New-B Regulatory Domain for US Theater

Recent changes in United States FCC rules requires shifting products from -A domain to -B domain effective June 2, 2016. Access Points using -A domain can continue to operate in the US after the June deadline but all new access points being manufactured or sold after June 2 must be -B domain.

Figure 1: Spectrum chart depicting new channels in the -B domain

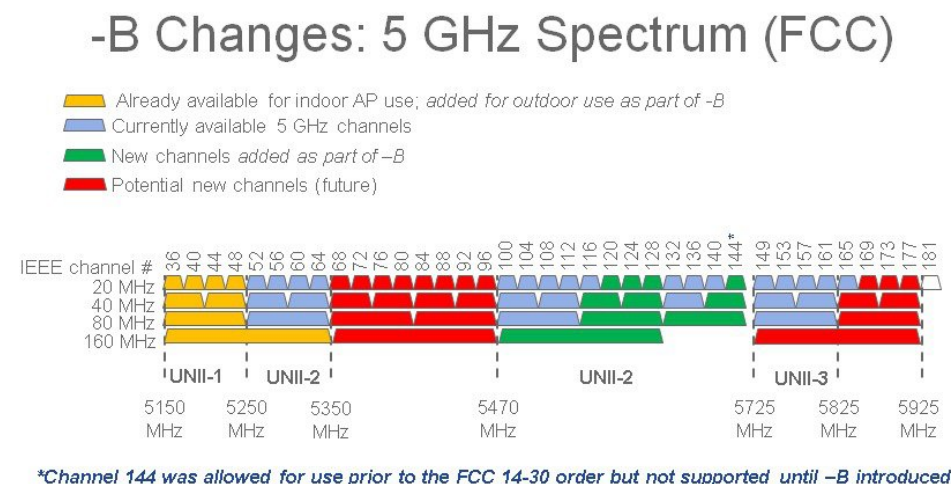
- U-NII 1 band (5150-5250 MHz) is now allowed for outdoor use. (+4 channels)
- In the U-NII 1 band (5150-5250 MHz) the allowed TX power level is increased to 1W (for indoor, outdoor, point to point) with extreme restrictions on EIRP above 30-degree horizon when used outdoors
- The Terminal Doppler Weather Radar (TDWR) bands (channels 120, 124, 128) are re-opened with new test requirements for Dynamic Frequency Selection (DFS) protection. (+3 channels)
- New power spectral density and above/below band edge emissions requirements for U-NII3 (5.725-5.85 GHz)
